California Historic State Capitol Commission

RE: Capitol Annex Project Recirculated Draft Environmental Impact Report

Historic State Capitol Commission Comments on Recirculated Draft Environmental Impact Report for the East Annex project

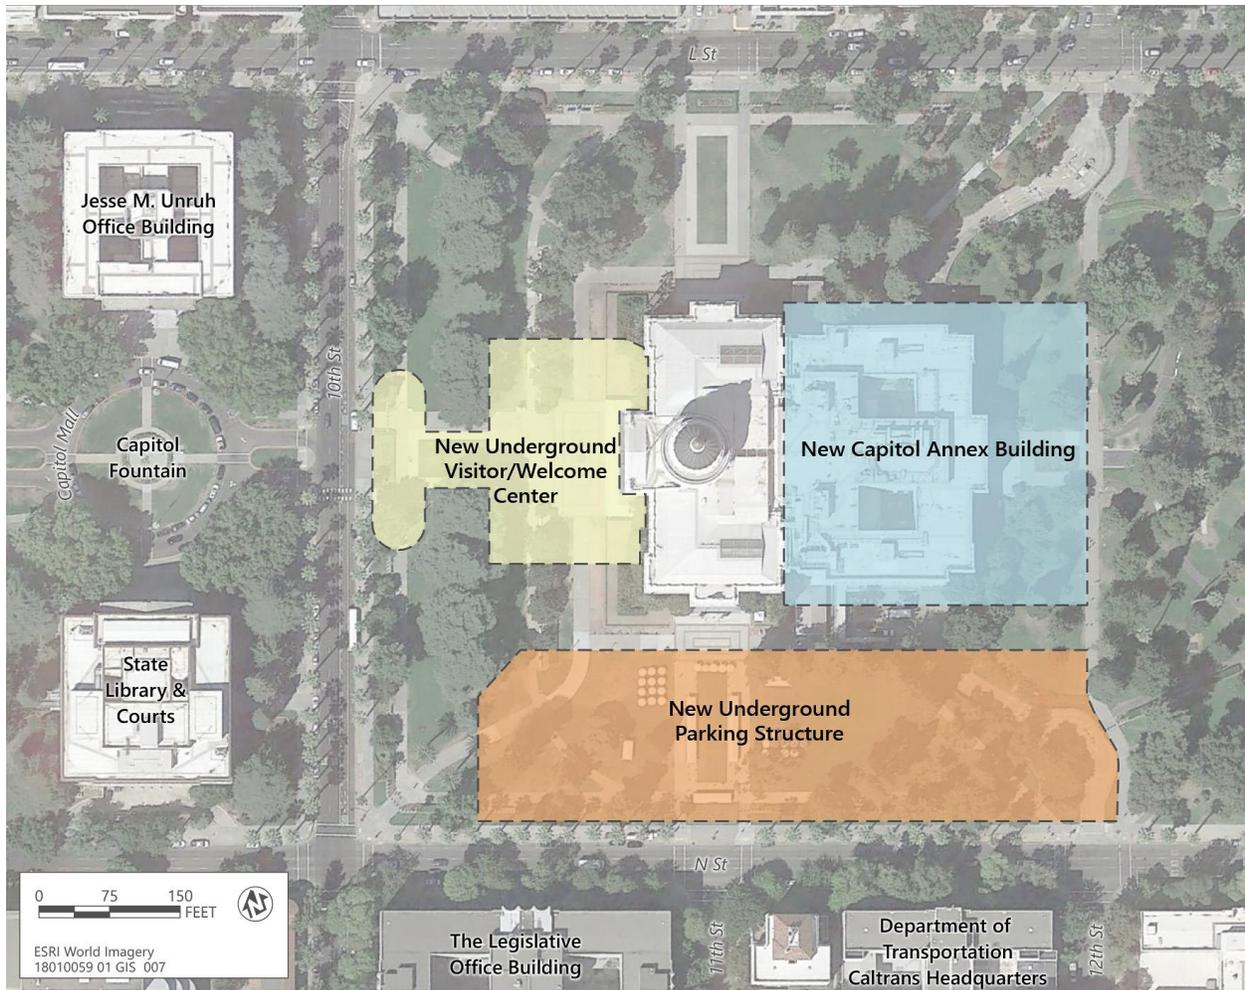
COMMENT: Please indicate:

- 1) whether the three levels will be maintained in areas outside the proposed Visitor/Welcome Center project area, and how the transition would be handled between the two areas, at both the north and south sides of the proposed Visitor/Welcome Center project area: and,

- 2) how the drought-tolerant and California native plants will be appropriate to the historic landscape features and characteristics of Capitol Park.
- 3) Again, this seems to conflict with “landscaping back to original”.
- 4) The earlier DEIR Option 2 for the Visitor/Welcome Center in the POS would greatly reduce the impact to the landscape and Historic Capitol while also reducing costs.
